**ADDENDUM NUMBER 1
BID NUMBER IFB 21-006**

RTU Replacement (Various Locations)

Addendum

PROJECT: KANSAS CITY KANSAS PUBLIC SCHOOLS ELEMENARY SCHOOL ROOFTOP
UNIT REPLACEMENTS

SHEET NUMBER: **ME2**

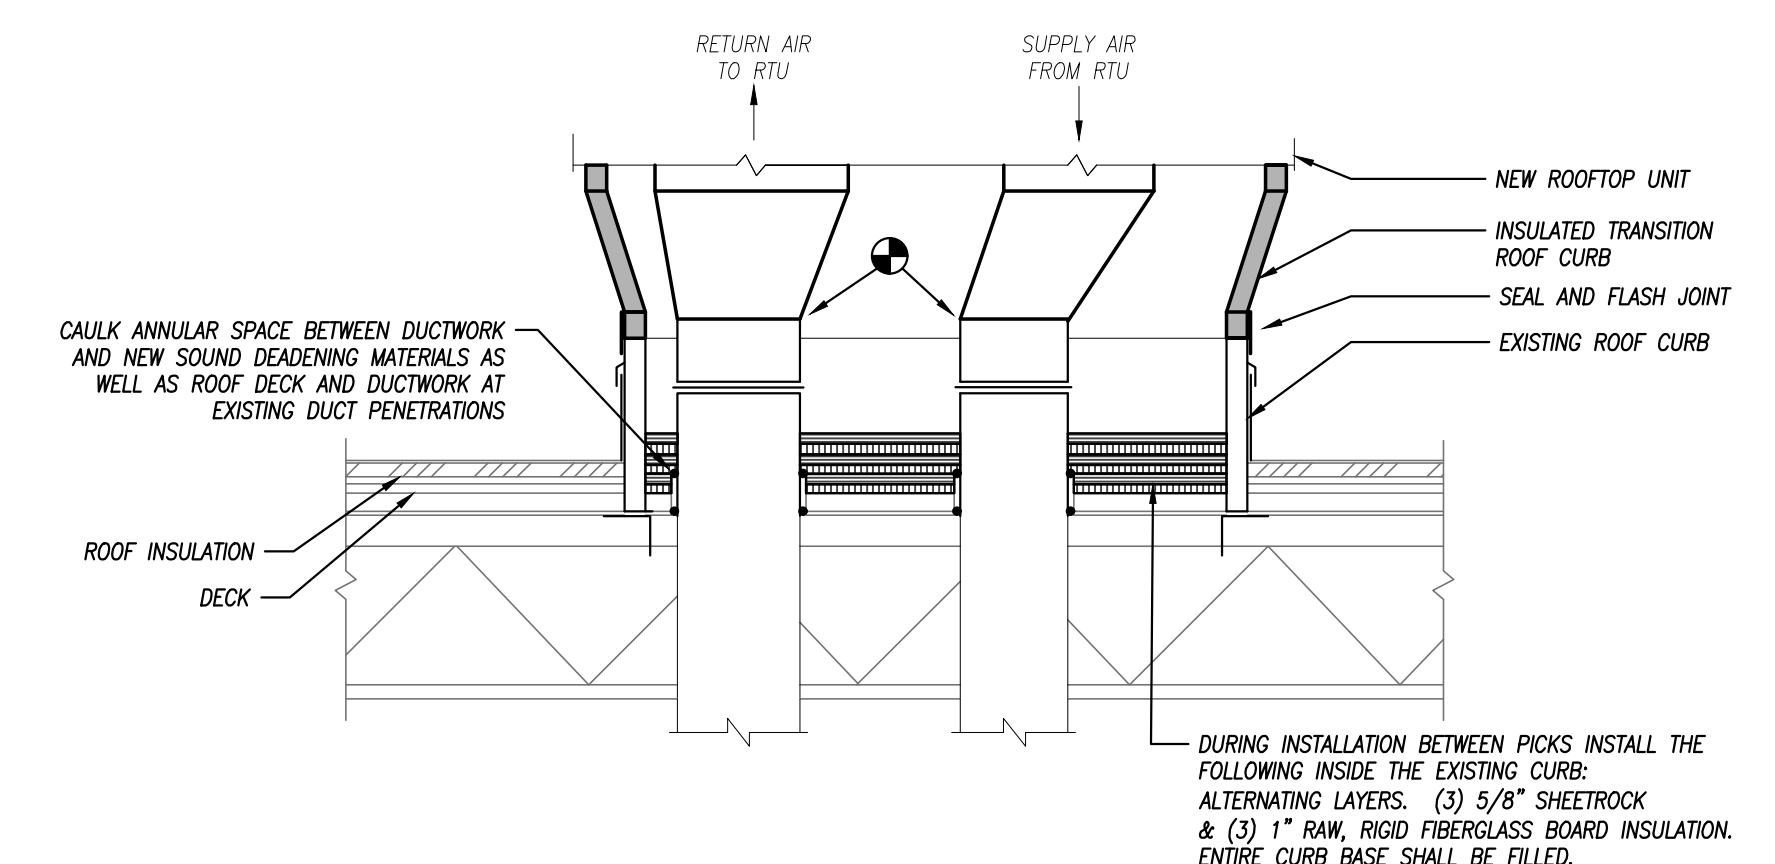
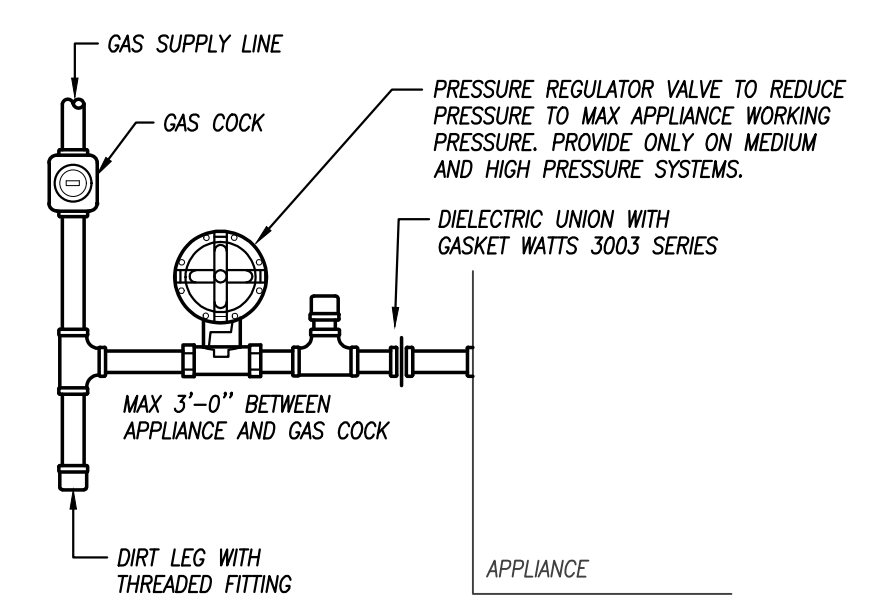
Sheet ME2:

1. Refer to revised sheet for replacement of rooftop unit BRTU-3. Contractor to verify existing electrical requirements and match existing tonnage and electric heat capacities.
